# City of Alexandria, Virginia

## MEMORANDUM

**SUBJECT:** 220 SOUTH UNION STREET  
BAR CASE #2014-0037 and 2013-0321

Figure 1. PREVIOUS three building scheme (L) and CURRENT two building scheme (R)

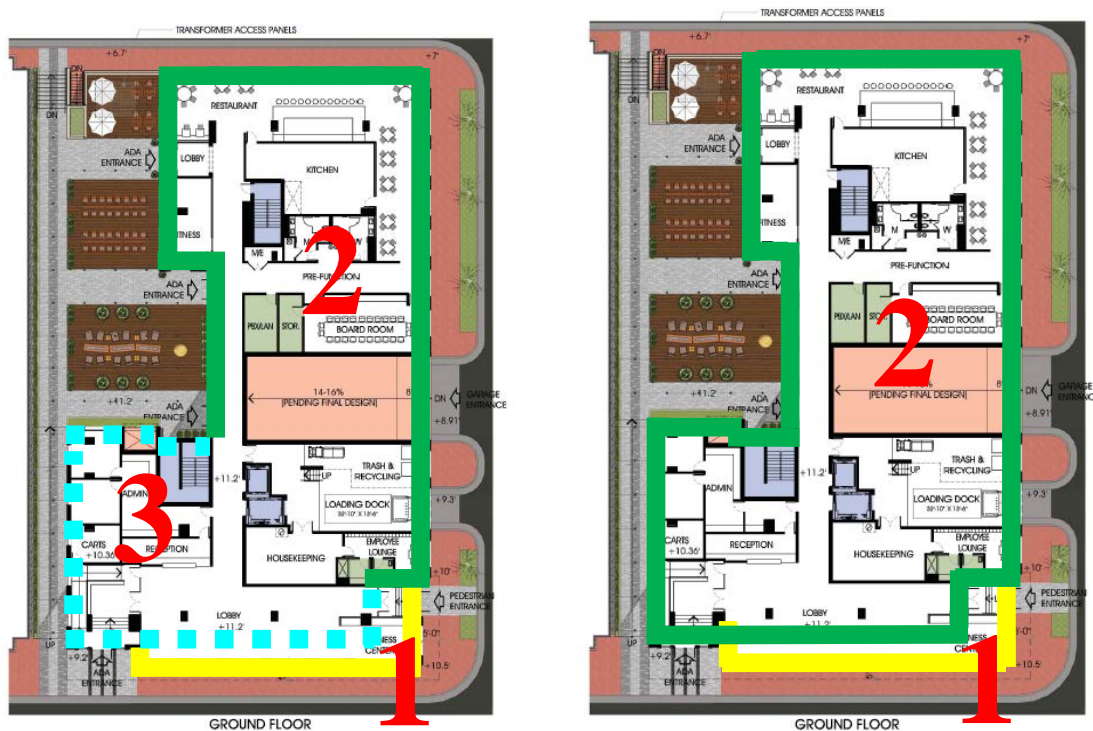
In the continuing effort to simplify the overall design, the project is now a clear two building configuration, as opposed to the previous three building scheme. The design retains the three-story red brick building element on South Union Street and combines what had previously been identified as buildings 2 and 3. Previously, building 3 was not well connected with the overall scheme and it was challenging to reconcile how it fit into the overall scheme. Adding a third brick color for that element resulted in a less harmonious and unnecessarily complex design.

PROPOSED SITE LIGHTING PLAN

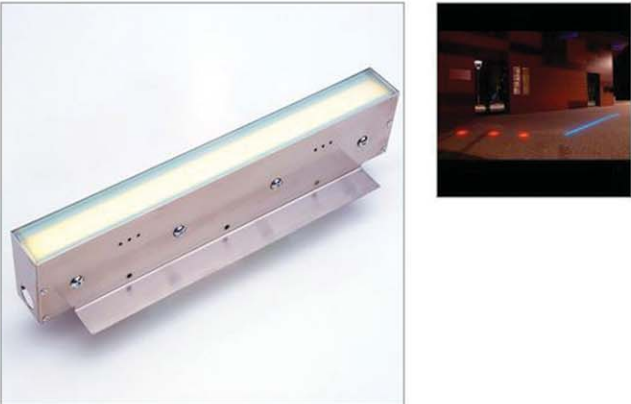
The applicant has provided a conceptual lighting plan indicating the general location of light fixtures. The Board did not find the wall mounted carriage-style lights to be appropriate and encouraged more contemporary and stylistically appropriate selections. The Board generally supported the building lighting plan and the courtyard lighting at the work session but recommended that the applicant return at a future date for approval of the remainder of the decorative lighting fixtures. The City Council also required the applicant to coordinate architectural lighting with the adjacent park lighting and this design must be approved by the BAR as well.

DUKE STREET - WALL SECTION AT MANSARD ROOF

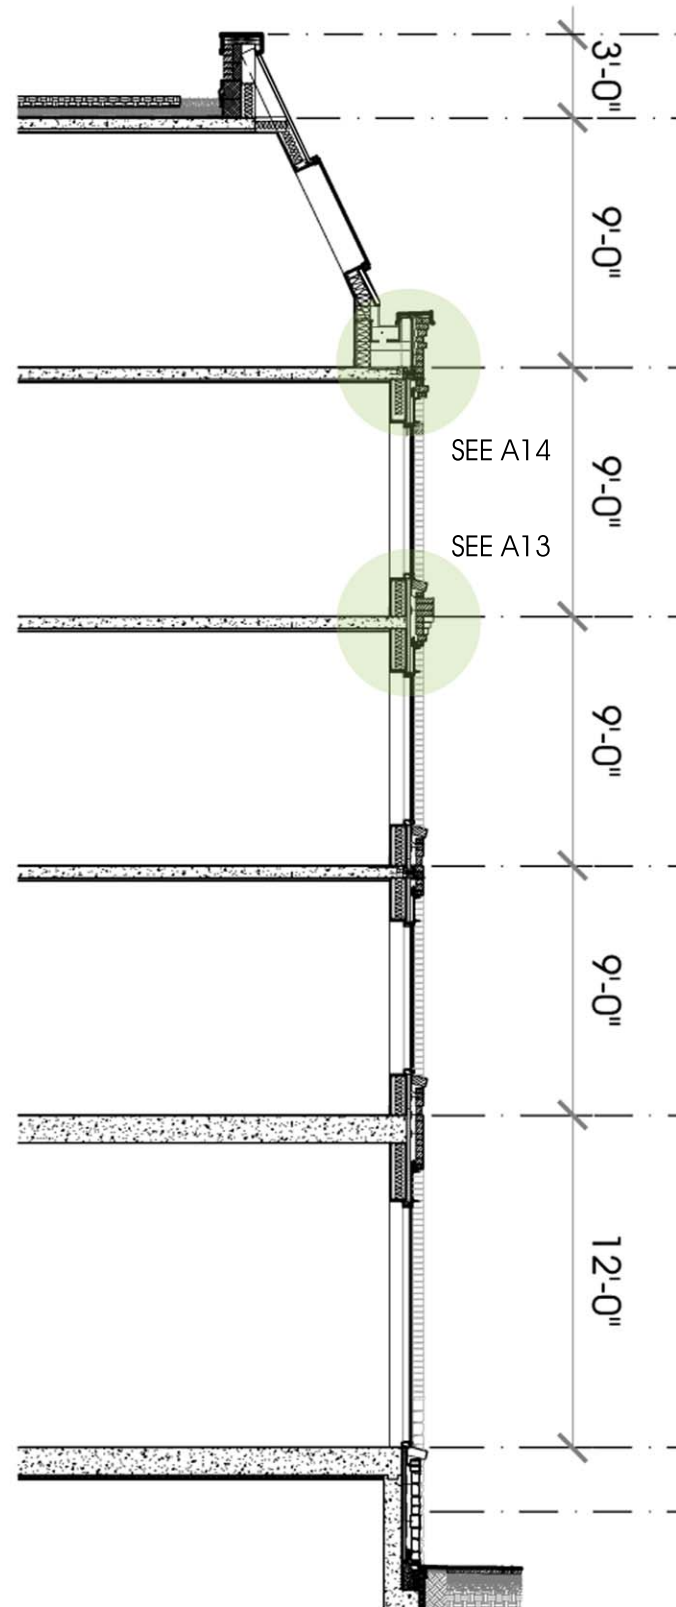
The wall section for Duke Street shows that the pitched roof will clearly be set back from the façade behind a cornice and gutter to allow the building to read as a four-story building with a clearly defined frieze at the 4<sup>th</sup> story and a pitched roof with shallow roof windows above. The details and sections of the cornice and corbelling indicate a depth and projection consistent with historic elements. Staff is satisfied that these building wall sections and masonry details ensure a well-proportioned, high-quality, appropriately detailed building and recommends approval.

PROPOSED EAST ELEVATION - STRAND STREET

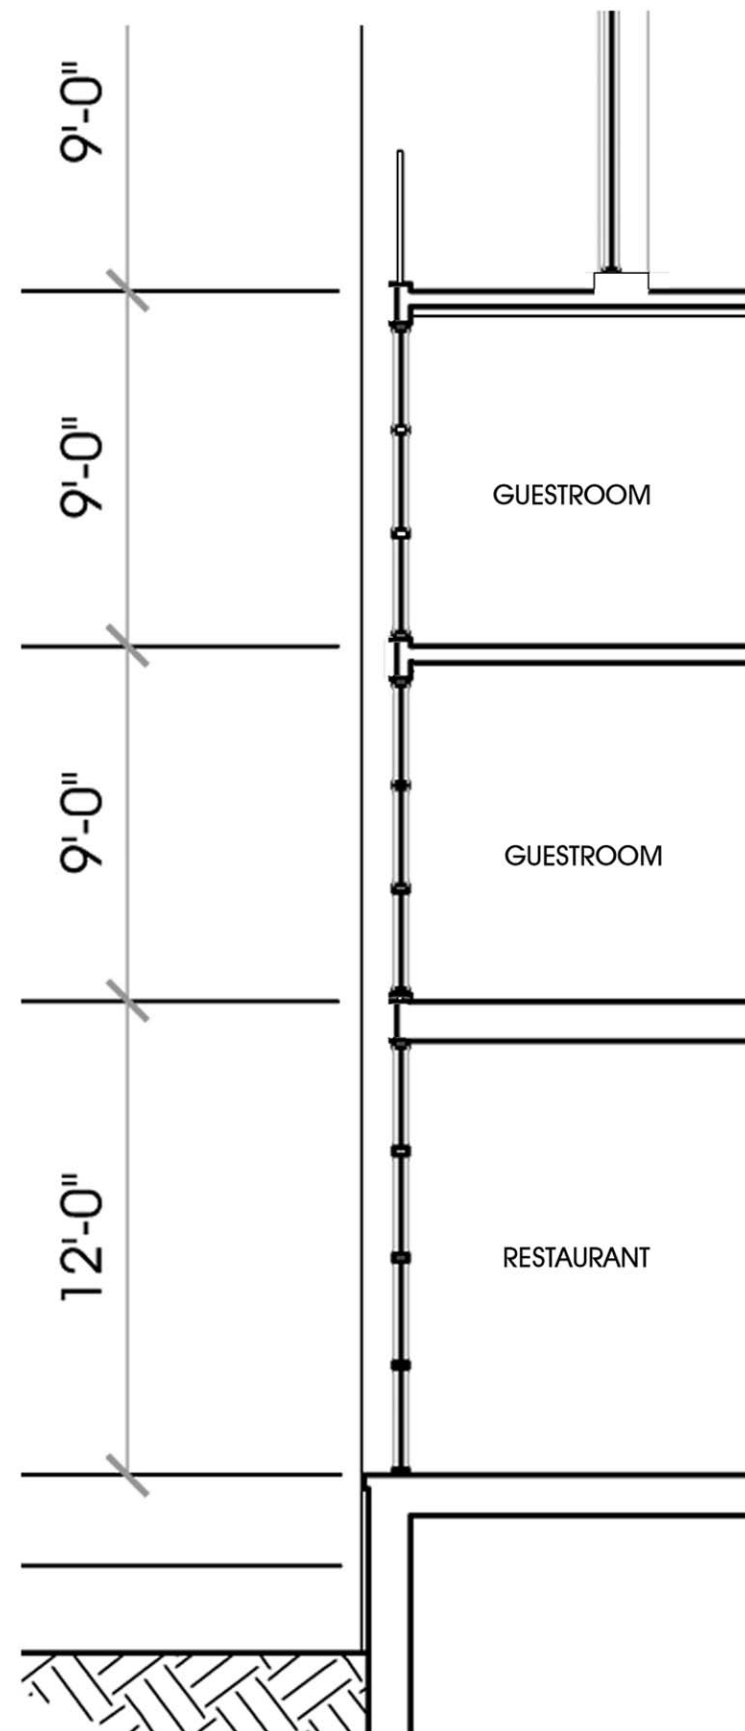
The Board has always focused on this elevation due to its prominence and visibility from the Potomac River and the future waterfront park. The applicant has been encouraged to showcase this elevation and promote a dialogue between the hotel and the park in this location. This elevation is an opportunity for operable windows, architectural lighting and innovative signage. The applicant studied the use of French doors for all the upper stories, with glass or metal railings, however their preference, stated at the work session, was for a two-story grouping of windows with spandrels between and only to have French doors with glass railings at the first floor. The Board members supported this design. In addition, the top of the lanterns (3<sup>rd</sup> story) will now have glass guardrails, as opposed to the previously shown metal pipe railings. The current scheme reflects the Board's work session comments.
